VALUE ENGINEERING REPORT

SR 20 Widening
Forsyth and Gwinnett Counties
STP-0002-00(392); PI No.: 0002392
BRST-054-1(63); PI No.: 132985
MLS-000-00(430); PI No.: 0004430

December 18, 2007

ITEM N^o: B-3.1
CLIENT: GDOT
Sheet 2 of 5

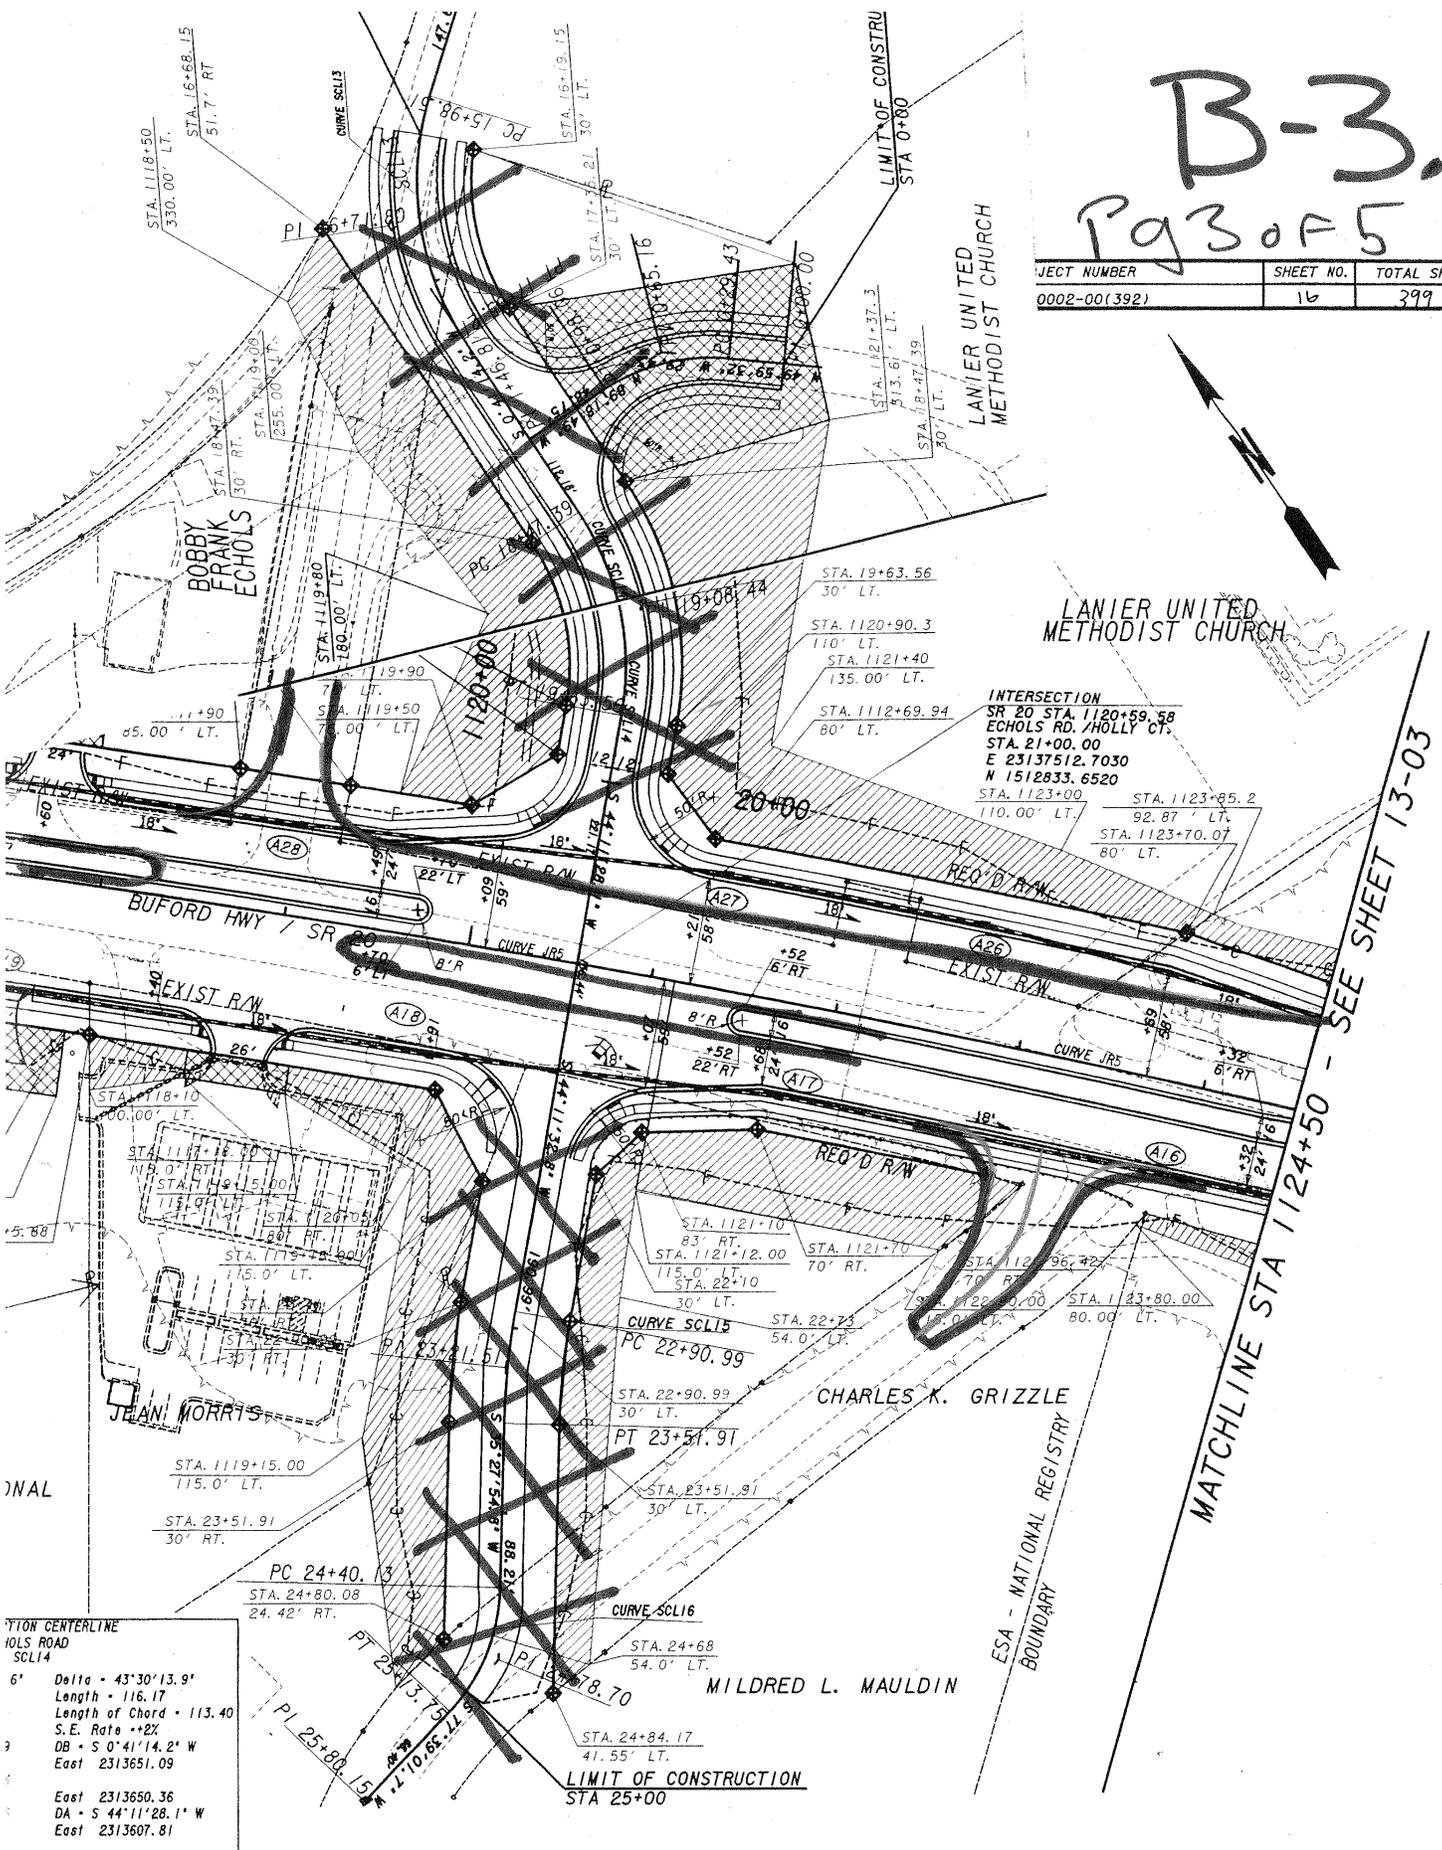
It appears that due to a proposed development on the south side at Holly Court, the intersection was realigned to provide a 4 leg perpendicular alignment with a median opening.

ITEM N^o: C-1
CLIENT: GDOT
Sheet 2 of 4

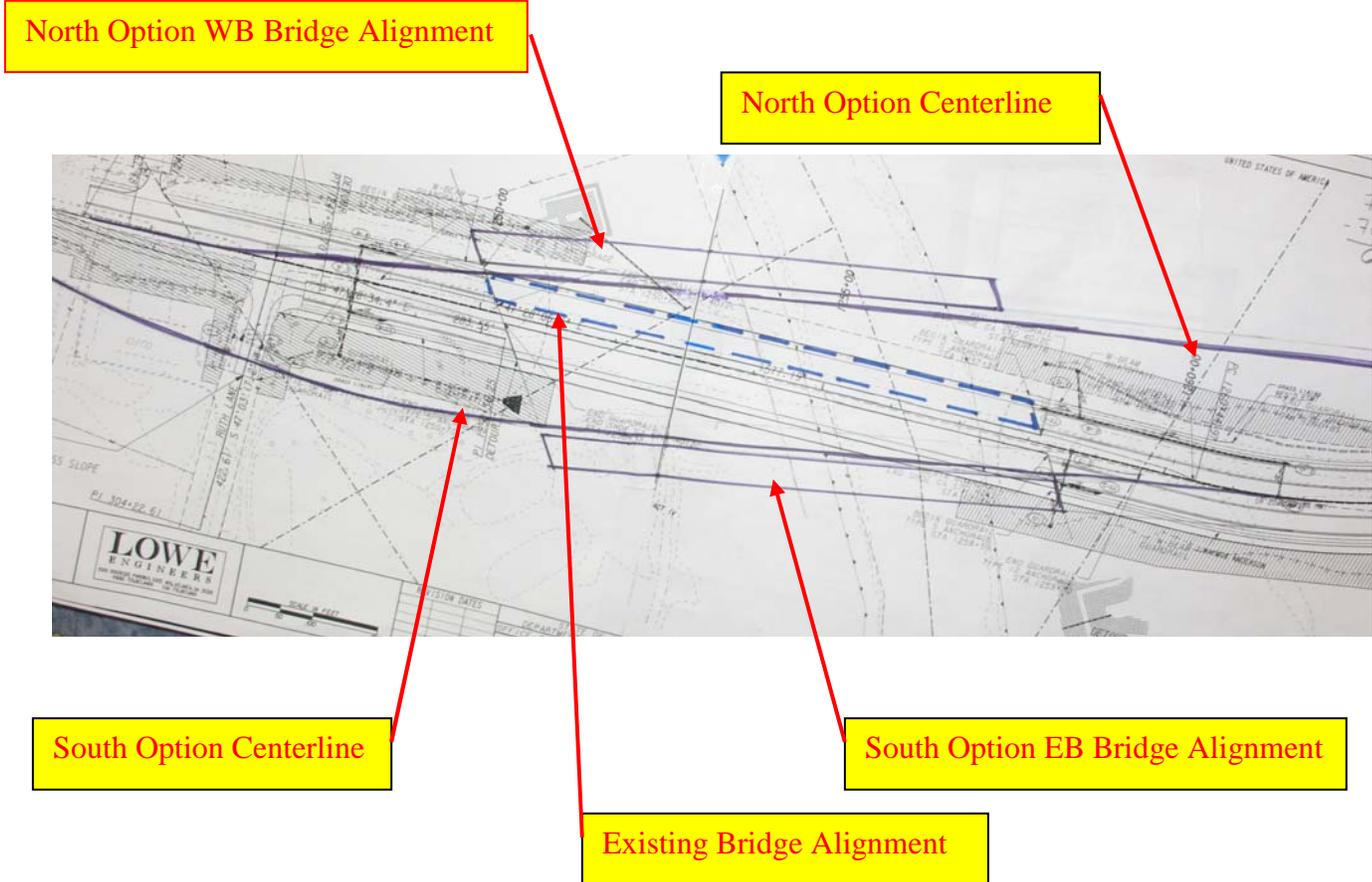
Proposed Change:

Realign the alignment to provide a more perpendicular crossing which will shorten the span and reduce the bridge length.

There are 2 alignments proposed; one to the north of the existing bridge and one to the south. Under both alignments, the bridges can be built “in the clear”. Each alignment shortens the bridge length from 793 feet to about 728 feet, a 65 foot savings. This recommendation will also provide a benefit of a shorter river span when selecting the main river span, which currently is about 400 feet to about 370 feet, 30 feet shorter. Even though 30 feet does not seem significant, it represents a 7.5% savings (30/400) which could be important in selecting the main crossing. Each realignment option will have additional property impacts. The southern alignment will actually reduce impacts to the park, potentially eliminating the 4f issue although it will affect the trout camp more severely. The north alignment will require additional 4f impacts and a large cut at the northeast quadrant. This is an opportunity to provide a better river crossing with fewer environmental impacts with a more perpendicular, shorter crossing, rather than just replacing in-kind with a parallel bridge. There will be a modest cost savings and an overall better crossing.

ITEM N^o: C-3A
CLIENT: GDOT
Sheet 2 of 4

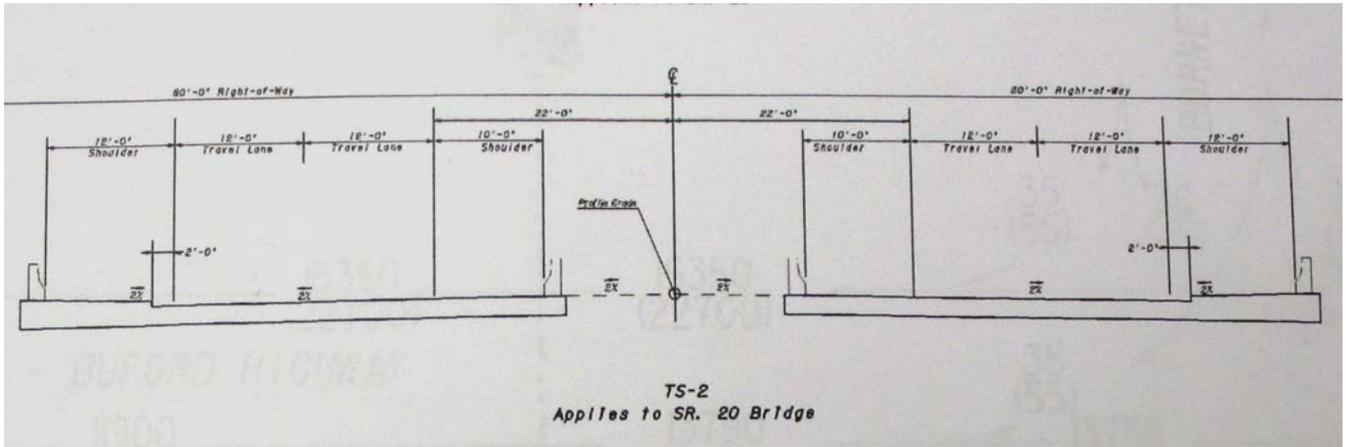
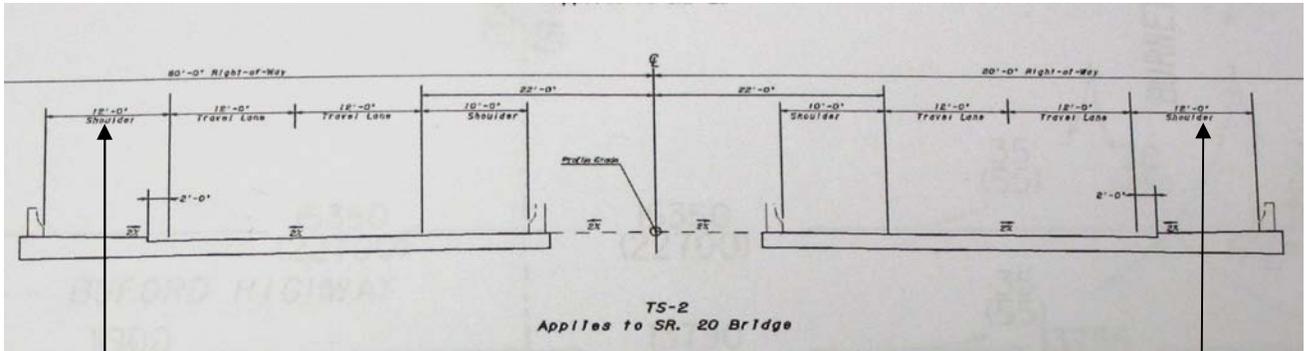
Conceptual drawings show 10 feet concrete sidewalks on both bridges.

Reduce to 8 feet (6 feet side walk)

ITEM N^o: C-3B
CLIENT: GDOT
Sheet 2 of 4

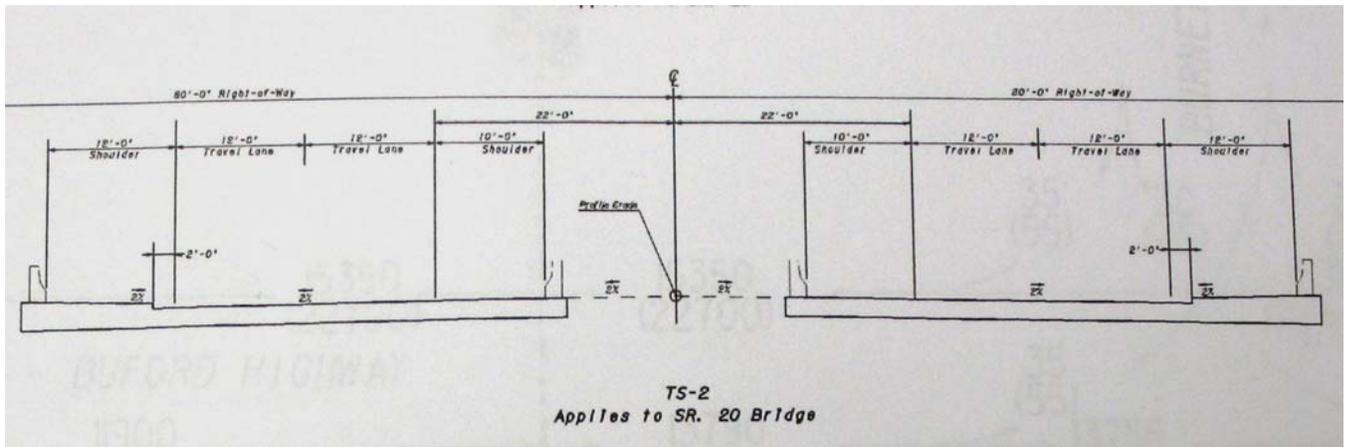
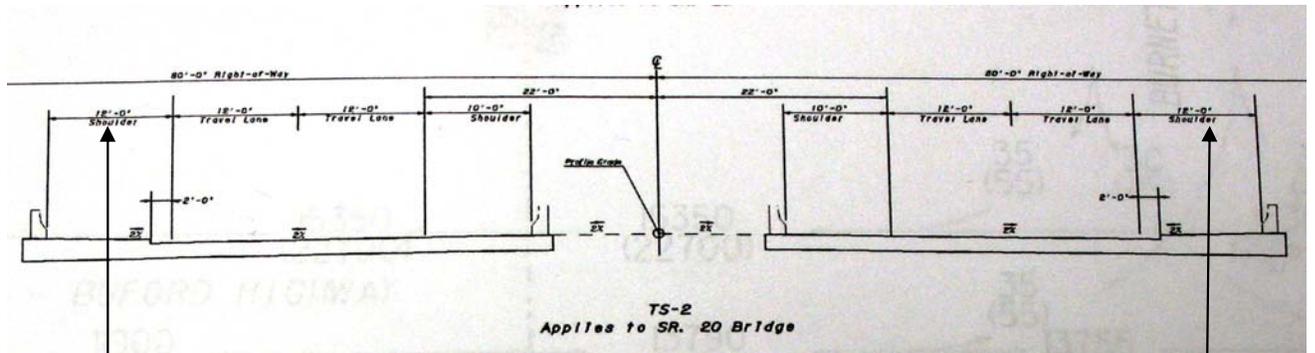
Conceptual drawings show 10 feet concrete sidewalks on both bridges.

Reduce to 2 feet (eliminate side walk)

Reduce to 8 feet (6 feet side walk)

ITEM N^o: C-5
CLIENT: GDOT
Sheet 2 of 4

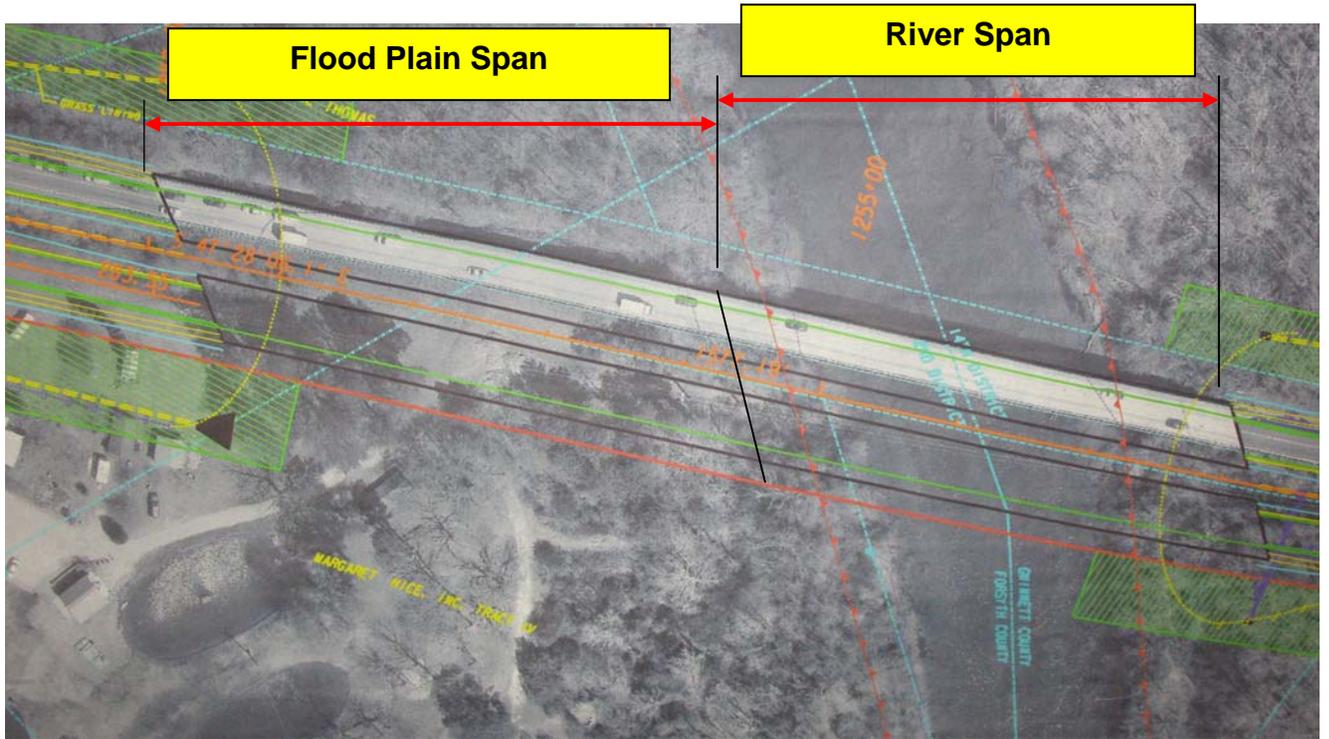
The original bridge was built prior to the construction of the dam which is located about 1 mile upstream. The flood plain has changed dramatically since the dam was completed. The proposed new bridges span the old flood plain as well as the river. This concept questions whether the old flood plain is flood plain at all as the dam controls all discharge. The bridge could be cut almost in half if this were the case.

ITEM N^o: C-8A
CLIENT: GDOT
Sheet 2 of 4

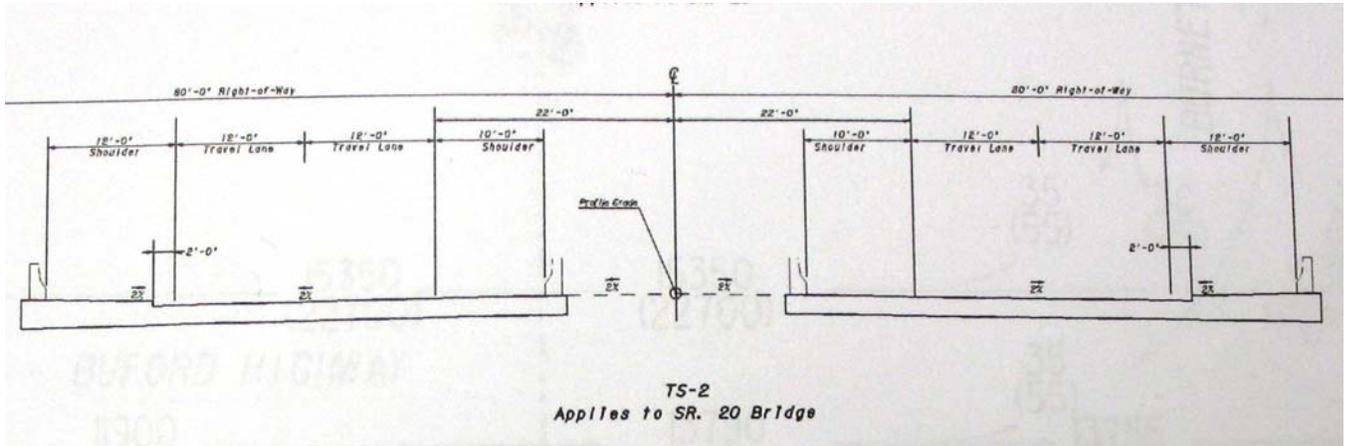
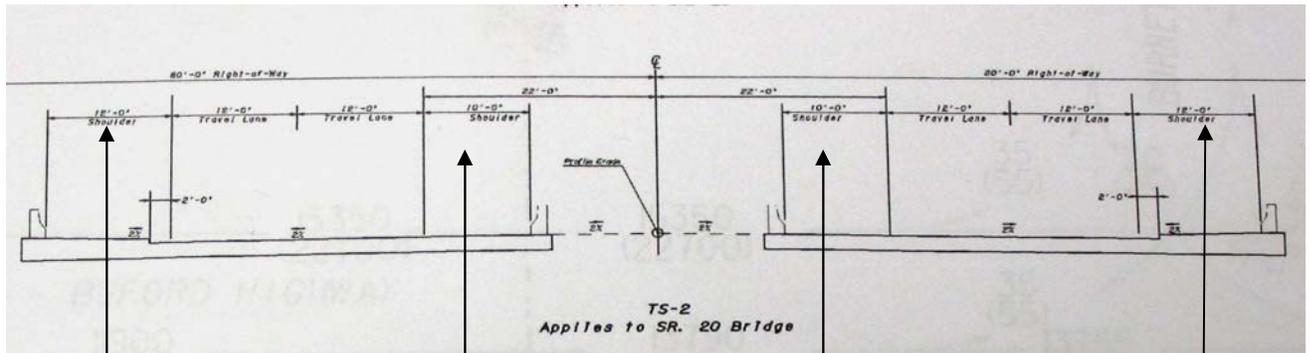
Conceptual drawings show 10 foot concrete sidewalks on both bridges and 10 foot inside shoulders.

Reduce to 4 foot
shoulders

Reduce to 8 feet (6 foot sidewalk)

ITEM N^o: C-8B
CLIENT: GDOT
Sheet 2 of 4

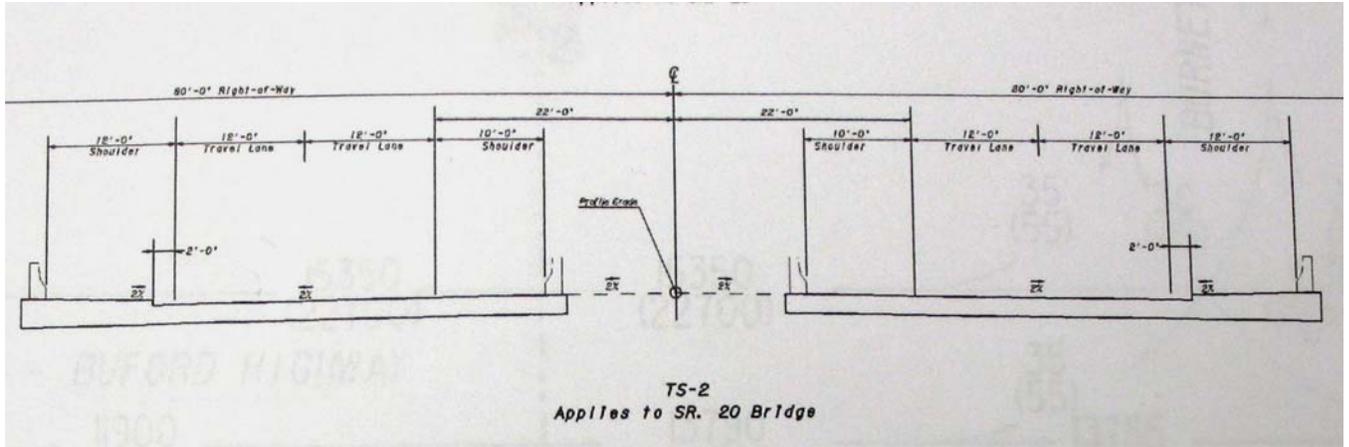
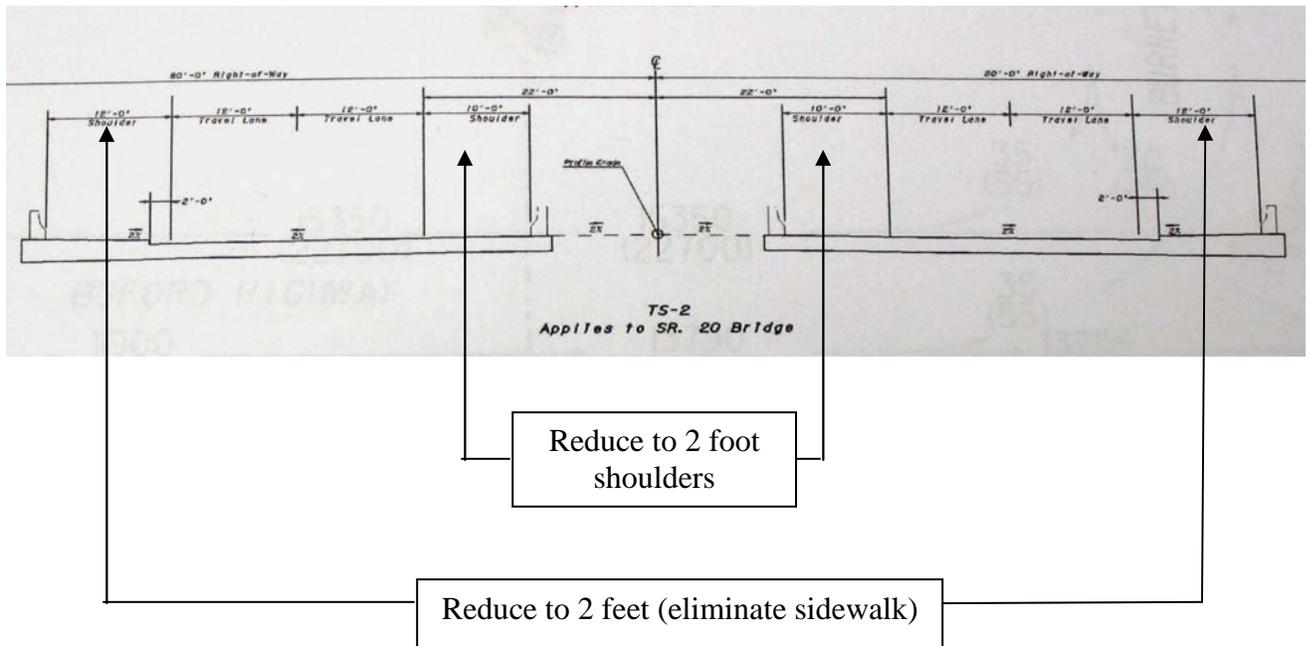
IDEA No.:	PAGE No.:	CREATIVE IDEA:
C-8B	1 of 4	Reduce inside shoulder width to 2 feet and remove sidewalks on both bridges.

Conceptual drawings show 10 feet concrete sidewalks on both bridges and 10 feet inside shoulders.
